# CITY OF ALBUQUERQUE

**RE: Albuquerque Central Care Center  
621 Columbia Dr. SE  
Grading and Drainage Plan  
Engineer's Stamp Date: 12/13/19  
Hydrology File: L16D042**

Based upon the information provided in your resubmittal received 03/03/2020, the Grading & Drainage Plan is approved for Building Permit.

**GRADING & DRAINAGE PLAN**

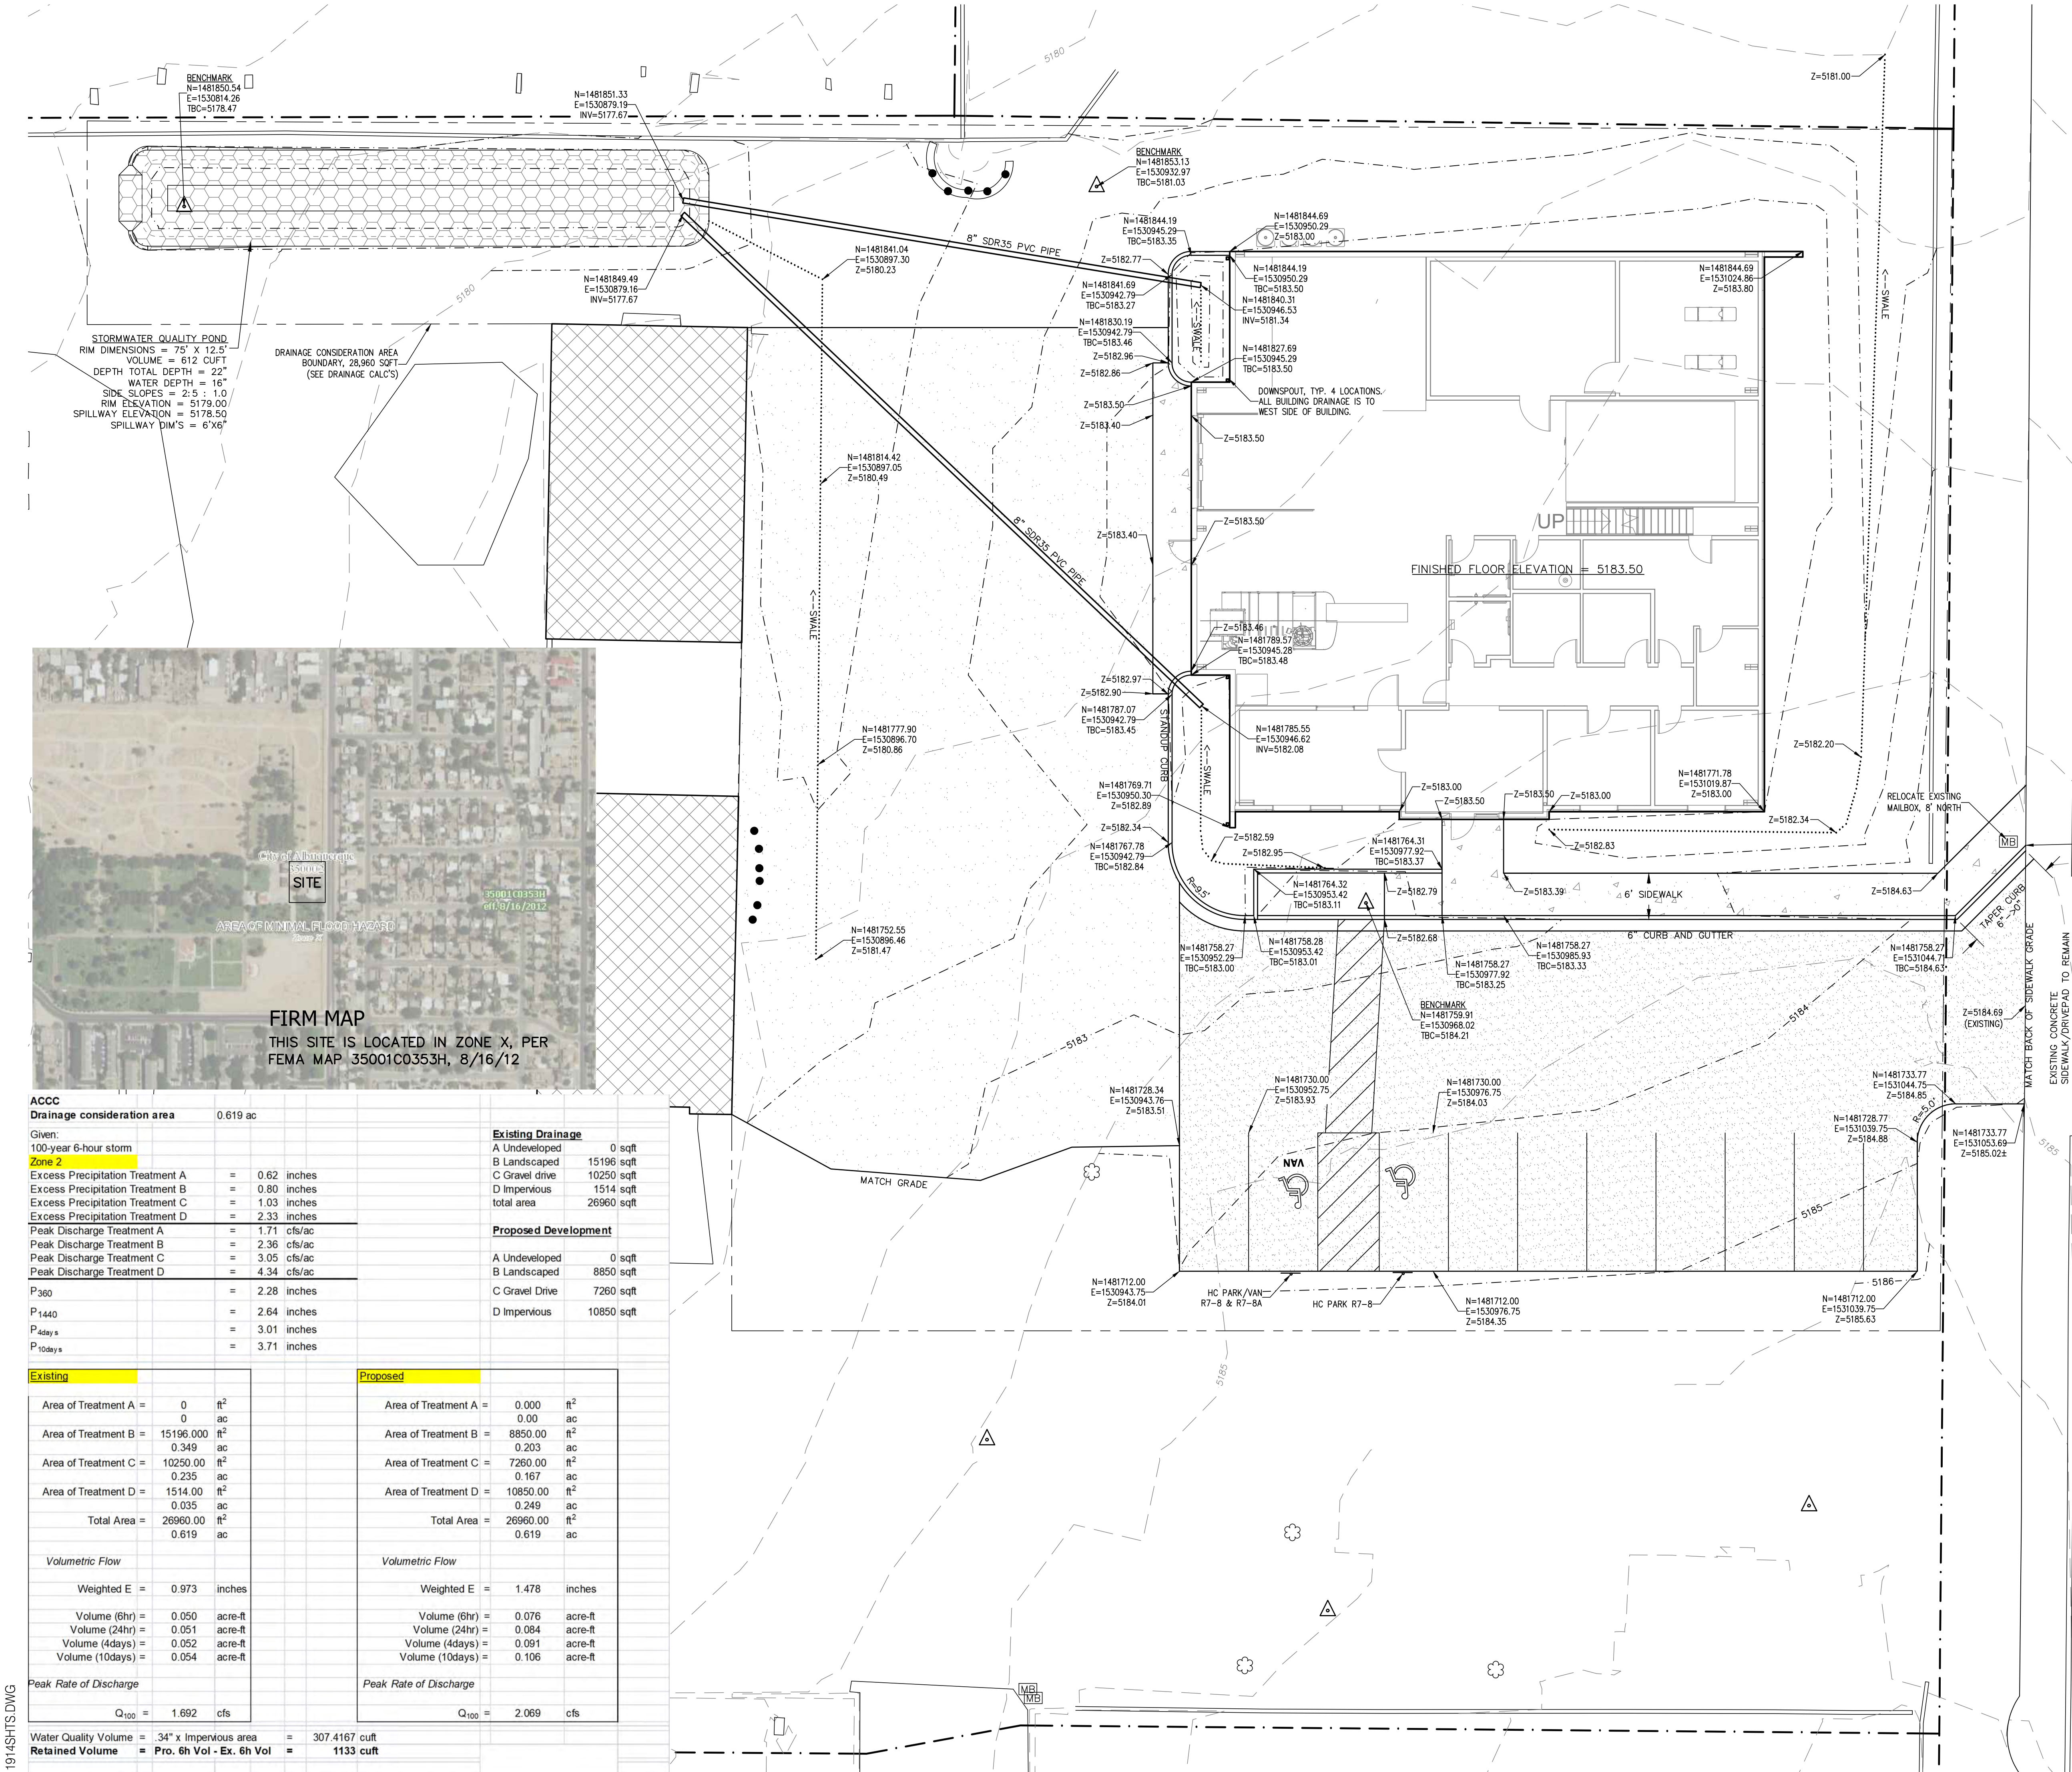
Please attach a copy of this approved plan in the construction sets for Building Permit processing along with a copy of this letter. Prior to approval in support of Permanent Release of Occupancy by Hydrology, Engineer Certification per the DPM checklist will be required.

Also as a reminder, please provide a Drainage Covenant for the proposed stormwater quality pond per Chapter 17 of the DPM prior to Permanent Release of Occupancy. Please submit this on the 4th floor of Plaza de Sol. A \$25 fee will be required.
